Appl. No. 10/811,780
Amdt. dated July 27, 2006
Reply to Office Action of April 7, 2006

Amendments to the Drawings

Remarks/Arguments

Fig. 1 "A"

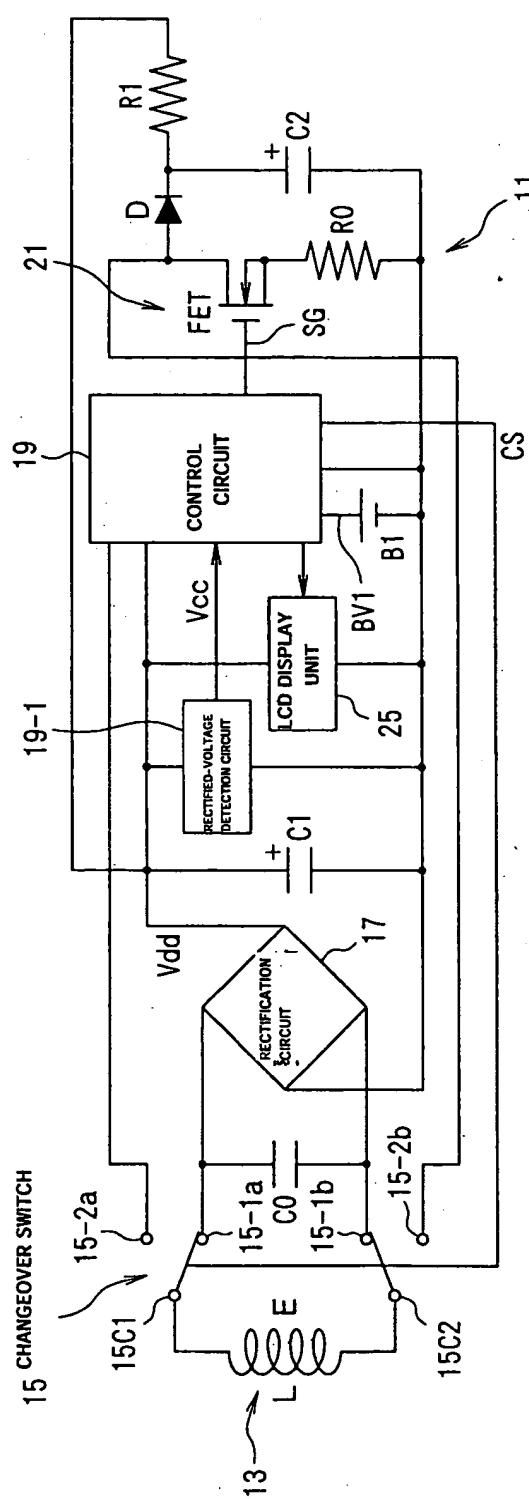
The Action objects to the drawings under 37 CFR 1.83(a) and asserts that they fail to show the booster circuit recited in the claims and described in the specification.

As is clearly described in applicant's specification (see paragraphs [0019]-[0022] and [0029]-[0031], for example), the contactless-tag electronic circuit 11 of Fig. 1 (and Fig. 4) includes a changeover switch 15 that switches circuit 11 between two states: a resonance circuit-formed state including an antenna coil L and a rectification circuit 17, which is formed when contacts 15c1 and 15c2 of antenna coil L connect to a first set of connection terminals 15-1a and 15-1b; and a booster circuit-formed state including antenna coil L and a charge pump 21 including a transistor FET, which is formed when contacts 15c1 and 15c2 of antenna coil L changeover to a second set of connection terminals 15-2a and 15-2b.

Thus the booster circuit is a state of the circuit of Fig. 1 (and Fig. 4) wherein antenna coil contact terminals 15c1 and 15c2 connect to the second set of connection terminals 15-2a and 15-2b to couple charge pump 21 to antenna coil L. All of these elements are clearly shown in Fig. 1, so applicant respectfully traverses the objection that the booster circuit is not shown in the drawings.

Four replacement sheets of drawings are attached. Two of the replacement sheets include changes to Figs. 1 and 4 and replace the original drawing sheets including Figs. 1 and 4. Figs. 1 and 4 are re-designated as Figs. 1A and 4A. Annotated sheets showing changes accompany these replacement sheets.

Nevertheless, in order to clarify matters, the application is amended to include new Figs. 1B and 4B. Figs. 1B and 4B are the same as Figs. 1 and 4, with the exception that contacts 15c1 and 15c2 are connected to second connection terminals 15-2a and 15-2b, rather than first connection terminals 15-1a and 15-1b, as in Figs. 1 and 4. Thus, new Figs. 1B and 4B explicitly illustrate the connected

state where circuit 11 includes the booster circuit. No new matter is added, since new Figs. 1B and 4B merely illustrate that which is described in multiple locations in the specification. For consistency with the new Figures, Figs. 1 and 4 are redesignated as Figs. 1A and 4A, and the specification is amended as necessary to make reference to the new Figures.
